DRAINAGE AND TRANSPORTATION INFORMATION SHEET (REV 6/2018)

Project Title: 6404 CANAVIO Building Permit #: _____ Hydrology File #: _____

RE: **Lot 7 Block 8 Volcano Cliffs Unit 22 SAD 228**
6404 Canavio Pl. NW
Grading and Drainage Plan
Engineers Stamp Date; 3/11/2019(D10D003E7)
Revised Date; 7/8/2021
Pad Certification Date; 7/8/2021

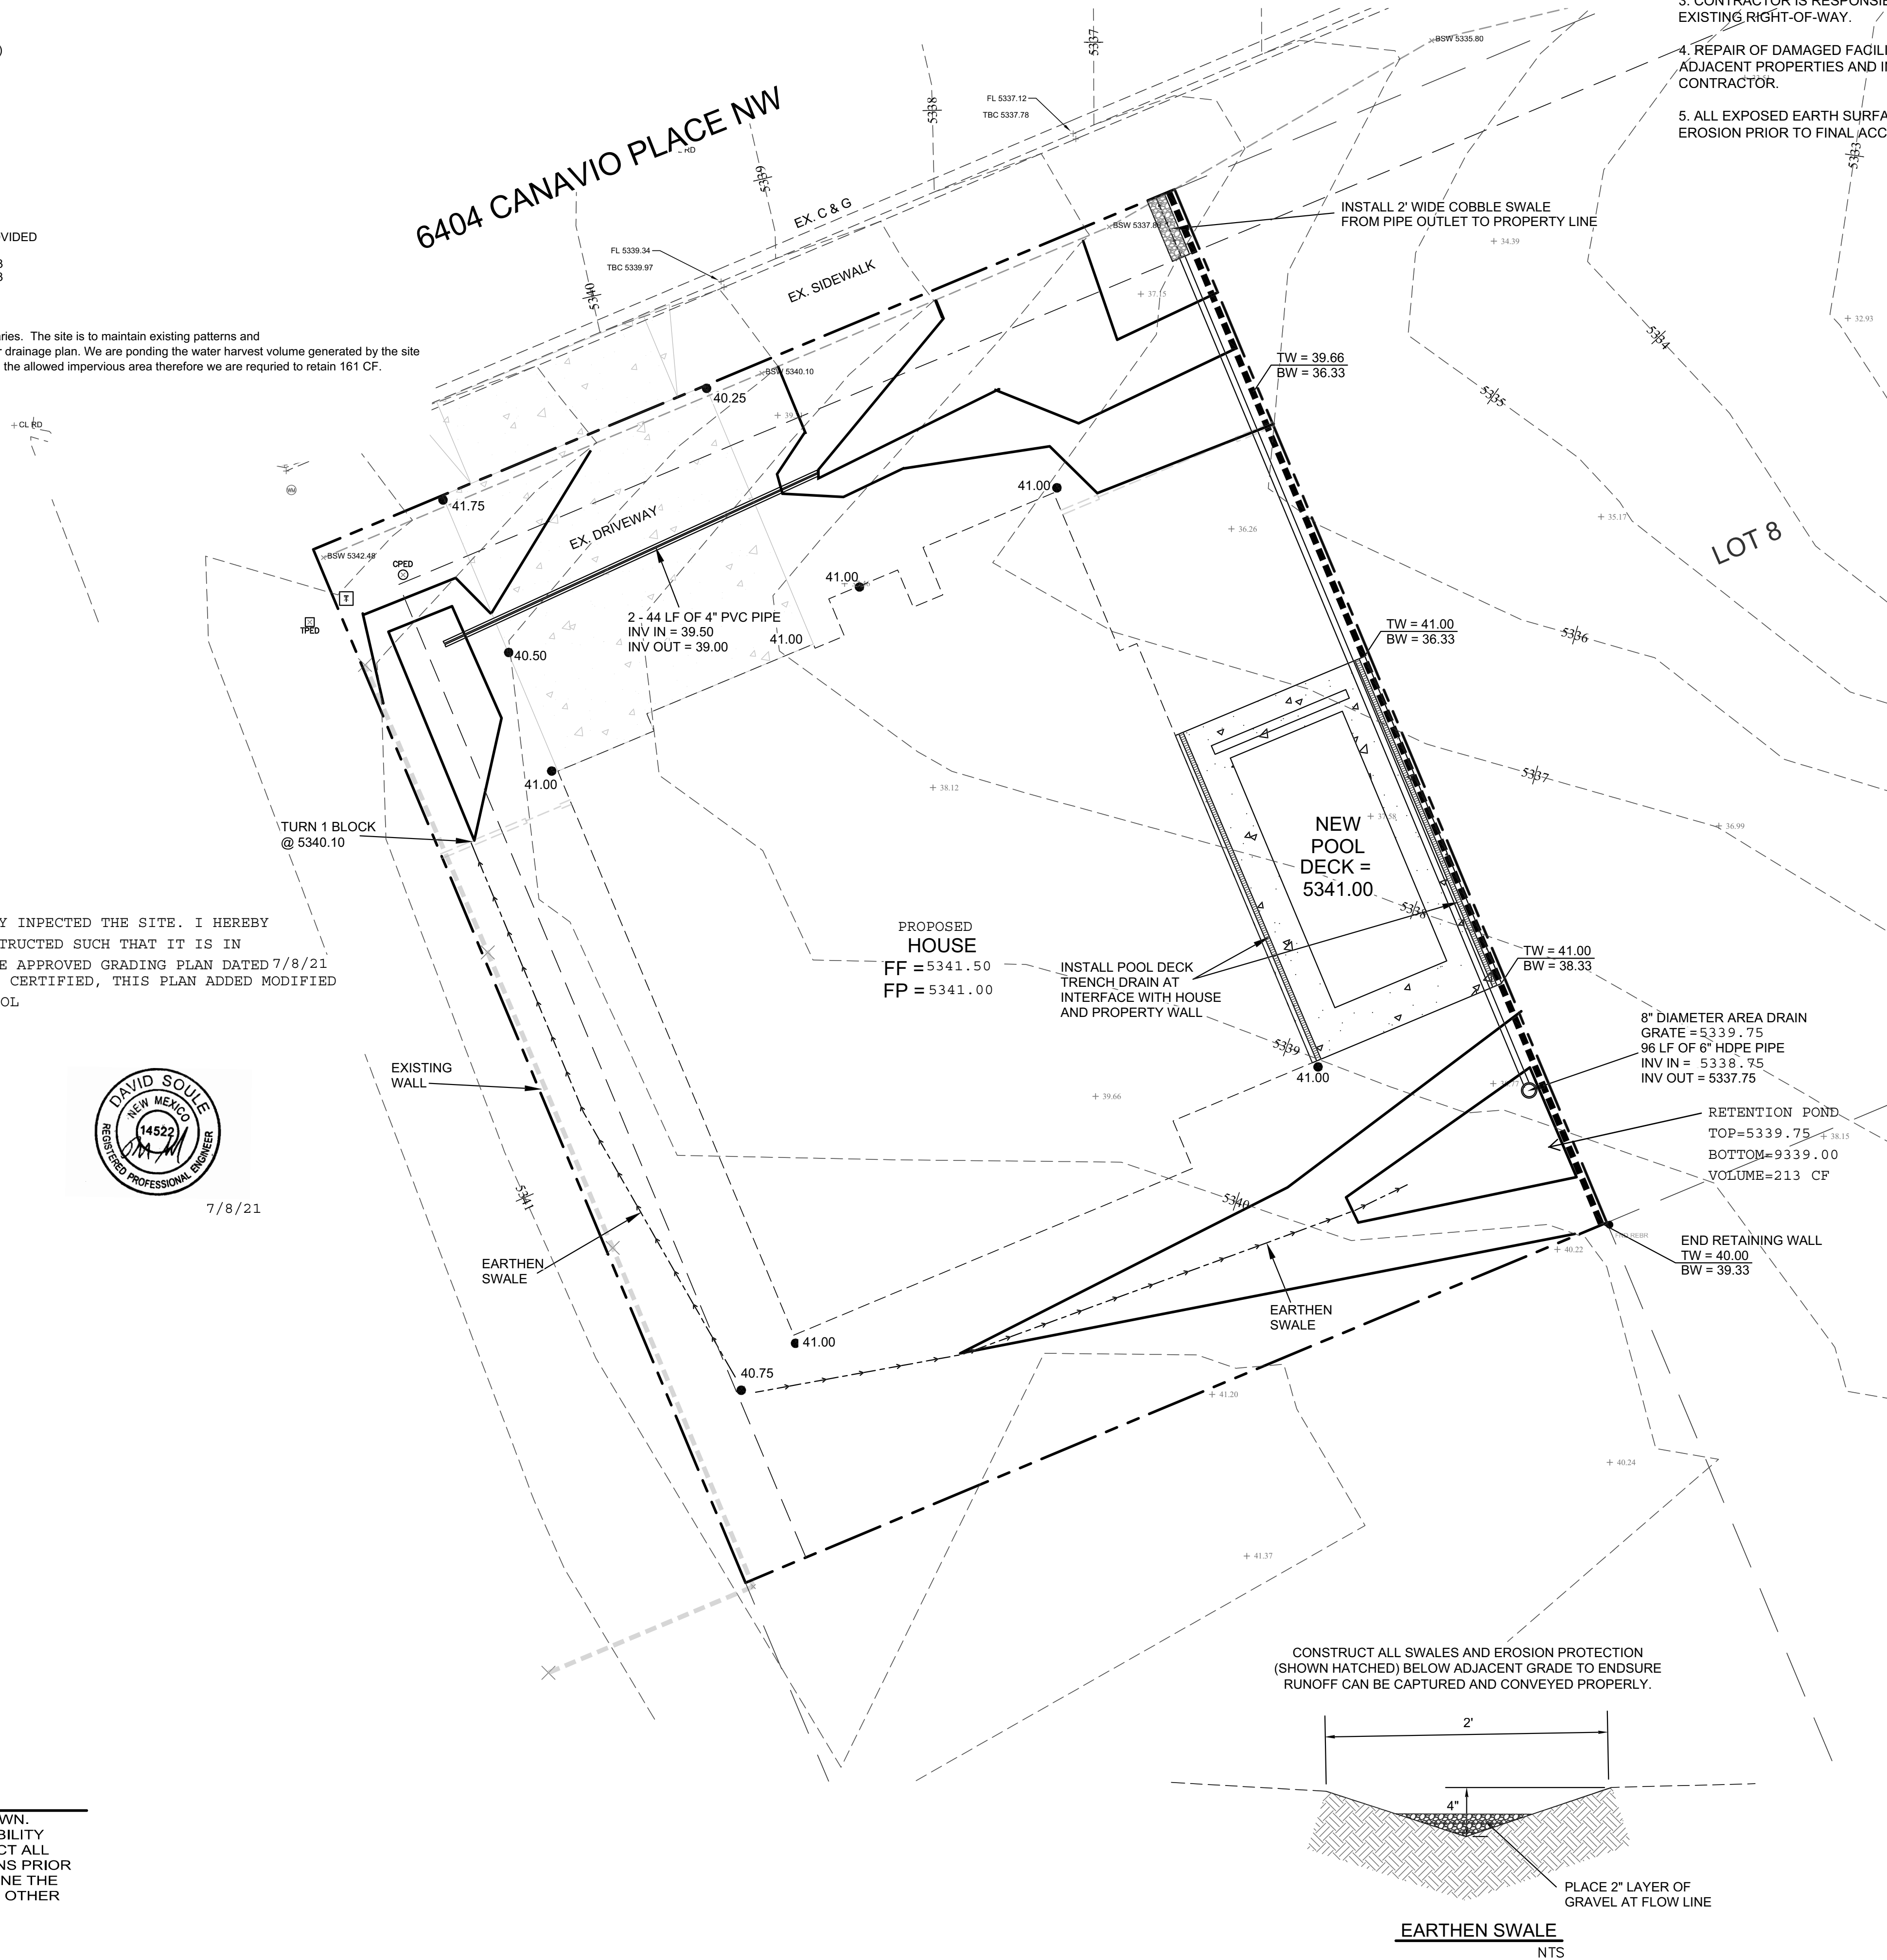
Based upon the information provided in your submittal received 7/9/2021, this revised plan dated 7/8/2021, is approved for Building Permit and Pool addition.

Reiterate to the Owner/Contractor that a separate permit for a garden/retaining wall must be obtained, with the approved G&D plan dated 7/8/2021 and Pad Certification Date 7/8/2021.

Prior to Certificate of Occupancy release, Engineer Certification per the DPM checklist of this plan will be required.
